Product Change Notification (PCN)

PCN Number	509569	Date Issued	November 16, 2020
Reason for Change	Packaging Method/Quantity Changing		
Change Type Description	This letter is to inform you that the part(s) referenced in this notice will undergo packaging specification changes that may include a new Delivery unit, packaging size, changes to the label or packaging material. No changes will be made to the product as a result of this change.		
Reason for Short Notice	Special Request		
Assessment of Change	Drop test approved		
Internal Molex Qualification Date	February 25, 2021		
Sample Availability Date (Changed Part)	February 25, 2021		
Planned Implementation Date	March 01, 2021

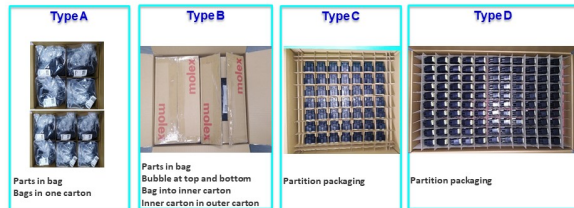
■ We will change the DU(SPQ) and packing method of MX150 series, the Air Bag packaging method has better cushioning and handling.

- Product Impact: no impact to fit, form or function.
- Part Number Impact: see attached impacted parts list (Note : all new PNs created between Oct 2020 and implementation date will have the DU changes as well)
- Qualification Reports and samples available upon request after the date shown above
